# CITY OF TAMPA

## ADDENDUM NO. 3

Contract 13-C-00020; Osborne Pumping Station Rehabilitation

**OSBORNE AVE. PUMPING STATION**  
**GENERAL NOTES**

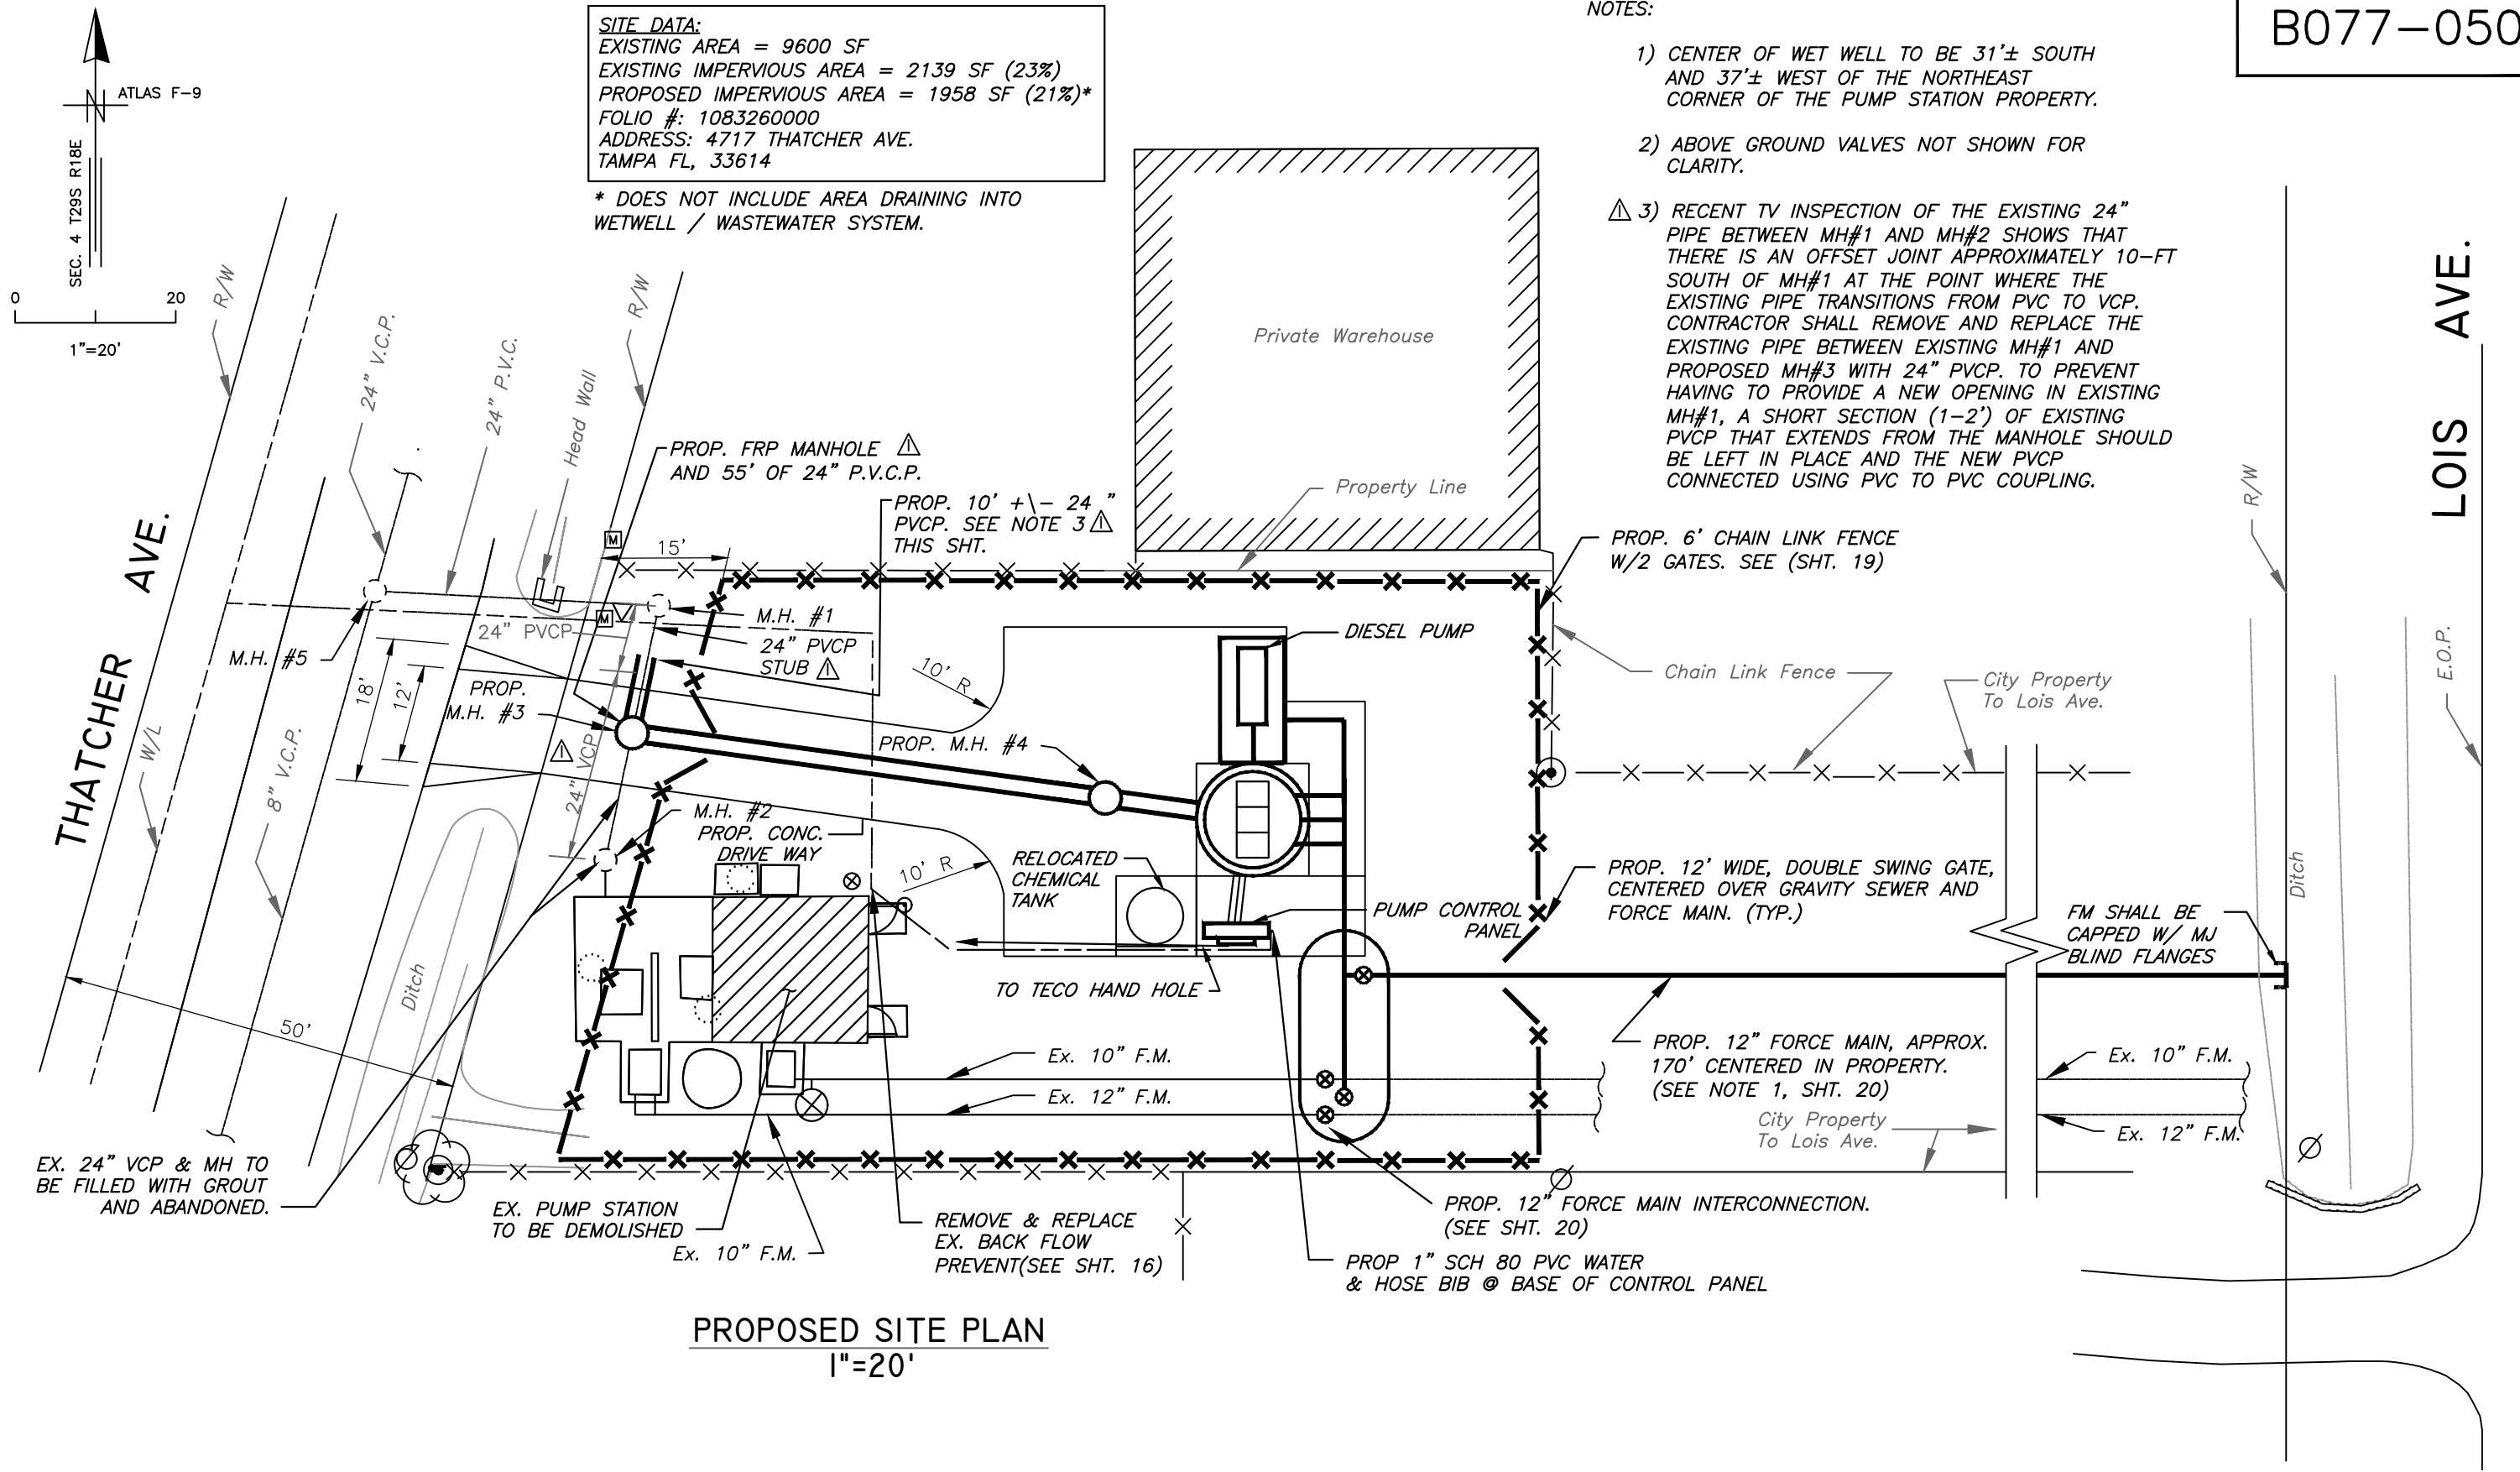
Item 2: Asbestos Survey Requirement Clarification: See attached revised Sheet No. 3, General Notes, Note G-34.

Item 3: Concrete Pavement and Subbase Clarification: See attached revised Sheet No. 3, General Notes, Note G-23.

Item 4: Proposed Construction Sequence Plan: See added notes on Sheet No. 3, General Notes, P-1 through P-10.

No.	DATE	REVISIONS
3		
2		
△	7/26/13	ADDED CONSTRUCTION SEQUENCE, CHANGED MH#3, ADDED NOTE 3 SHT 5, REVISED PROFILE

- △ G-23. ALL CONCRETE PAVEMENT, UNLESS OTHERWISE NOTED, SHALL BE MIN 6" THICK CONCRETE WITH 4X4 W2.1XW2.1 WWF. CONCRETE SHALL BE CONSTRUCTED ON COMPACTED SUBBASE (MINIMUM 98% MODIFIED PROCTOR) WITH 1.5" DEEP CONTROL JOINTS SAWCUT @ 15' MAX, CUT WITHIN 12 HRS OF CONCRETE PLACEMENT.

- △ G-34. THE CITY DOES NOT BELIEVE ASBESTOS IS PRESENT IN THE BUILDING. PER EPC REQUIREMENTS, CONTRACTOR WILL BE REQUIRED TO PROCURE A THIRD PARTY ASBESTOS SURVEY FROM A LICENSED ASBESTOS CONSULTANT. DEMOLITION OF PUMP STATION BUILDING CANNOT BEGIN UNTIL (3) WEEKS AFTER THE ASBESTOS SURVEY IS SUBMITTED TO THE ENGINEER. THE CITY WILL FURNISH EPC WITH THE REQUIRED NOTIFICATION. IF THE SURVEY DISCOVERS THE PRESENCE OF ASBESTOS, THE CITY WILL UTILIZE CONTINGENCY FUNDS FOR THE ASBESTOS REMOVAL IN ACCORDANCE WITH EPC STANDARDS.

△ PROPOSED CONSTRUCTION SEQUENCE PLAN

- P-1. INSTALL TEMPORARY BYPASS FROM MH#5 TO MH#2 TO ALLOW FOR CONSTRUCTION OF MH#3 AND INSTALLATION OF NEW PIPE FROM MH#1 AND MH#3.
- P-2. CONSTRUCT PROPOSED MH#3. REMOVE AND REPLACE APPROXIMATELY 10' +/- OF EXISTING 24" CLAY PIPE (BETWEEN MH#3 AND MH#1) AND REPLACE WITH 24" PVC. CONNECT TO EXISTING PVC WITH PVC TO PVC COUPLING. (SEE NOTE 3 PG 5) RECONNECT EXISTING PIPE TO THE SOUTH TO MH#3 AND PROVIDE STUB FOR CONSTRUCTION OF PIPE TO THE EAST.

- P-3. PLUG THE EAST INVERT OF MH#3 TO ALLOW FLOW TO CONTINUE TO EXISTING PUMP STATION AND REMOVE THE TEMPORARY BYPASS.
- P-4. CONSTRUCT PROPOSED SUBMERSIBLE PUMP STATION.

- P-5. CONSTRUCT PROPOSED INTERCONNECTION FORCE MAIN.
- P-6. COMPLETE CONSTRUCTION OF SUBMERSIBLE PUMP STATION INCLUDING ELECTRICAL CONNECTIONS AND CONNECT TO FORCE MAIN AS SHOWN IN THE INTERCONNECTION DETAIL. COMPLETE INFLUENT GRAVITY SEWER INCLUDING MH#4 AND CONNECTION TO MH#3.

- P-7. COMPLETE TESTING OF 24" GRAVITY SEWER, FORCE MAIN AND SUBMERSIBLE PUMP STATION.
- P-8. UPON COMPLETION AND SUCCESSFUL TESTING OF 24" GRAVITY SEWER, FORCE MAIN AND SUBMERSIBLE PUMP STATION; OPEN VALVES AS NEEDED TO PLACE NEW STATION INTO SERVICE.

- P-9. CLOSE VALVES AS NEEDED TO PLACE EXISTING STATION AND FORCE MAIN BETWEEN THE EXISTING STATION AND THE NEW STATION OUT OF OPERATION
- P-10. COMPLETE DEMOLITION OF EXISTING PUMP STATION.

**PROPOSED SITE PLAN**  
 1"=20'

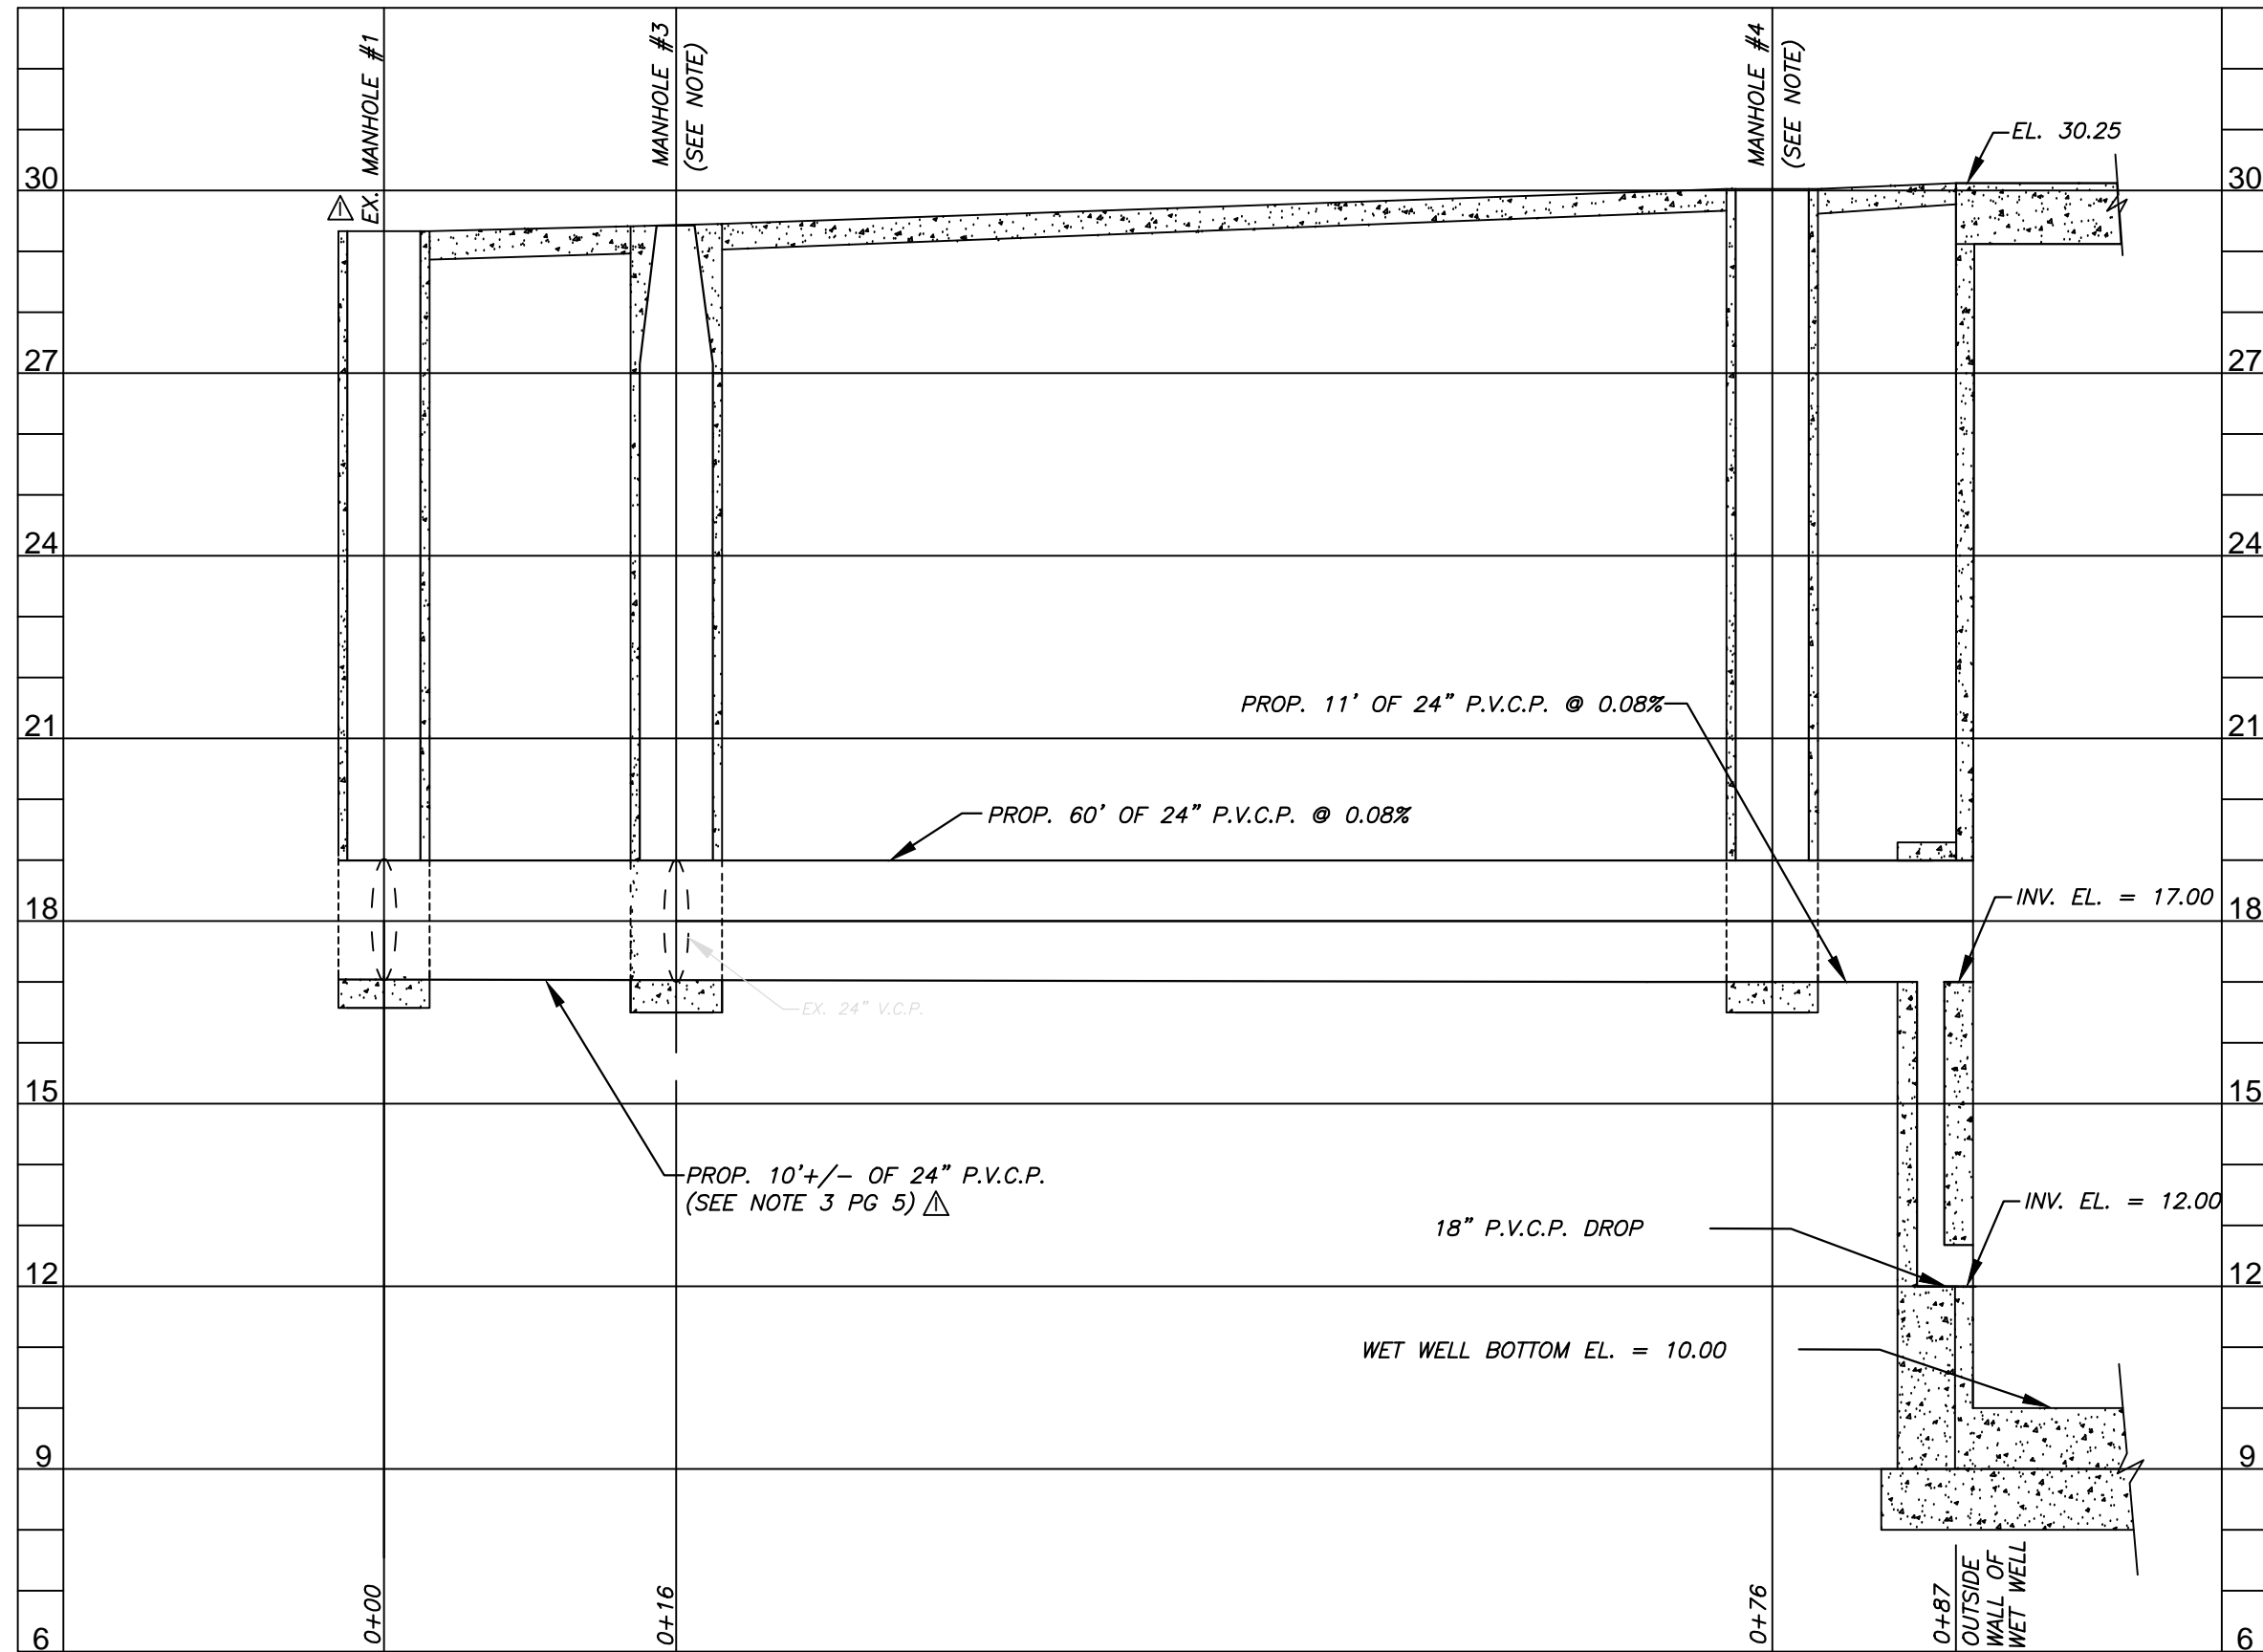
JACINTO CARLOS FERRAS, P.E. #49454 DESIGN DIVISION HEAD WASTEWATER DEPARTMENT	No.	DATE	REVISIONS	DES: M.S./J.F. DRN: W.A./J.H.J. CKD: DATE: 05/13/13	<b>CITY of TAMPA</b> WASTEWATER DEPARTMENT	OSBORNE AVE. PUMP STATION PROPOSED SITE PLAN	W.O. 5896
	3						SHEET
	2						5
	△	7/26/13	ADDED CONSTRUCTION SEQUENCE, CHANGED MH#3, ADDED NOTE 3 SHT 5, REVISED PROFILE

- 1) CENTER OF WET WELL TO BE 31'± SOUTH AND 37'± WEST OF THE NORTHEAST CORNER OF THE PUMP STATION PROPERTY.
- 2) ABOVE GROUND VALVES NOT SHOWN FOR CLARITY.
- 3) RECENT TV INSPECTION OF THE EXISTING 24" PIPE BETWEEN MH#1 AND MH#2 SHOWS THAT THERE IS AN OFFSET JOINT APPROXIMATELY 10-FT SOUTH OF MH#1 AT THE POINT WHERE THE EXISTING PIPE TRANSITIONS FROM PVC TO VCP. CONTRACTOR SHALL REMOVE AND REPLACE THE EXISTING PIPE BETWEEN EXISTING MH#1 AND PROPOSED MH#3 WITH 24" PVC. TO PREVENT HAVING TO PROVIDE A NEW OPENING IN EXISTING MH#1, A SHORT SECTION (1-2') OF EXISTING PVC THAT EXTENDS FROM THE MANHOLE SHOULD BE LEFT IN PLACE AND THE NEW PVC CONNECTED USING PVC TO PVC COUPLING.
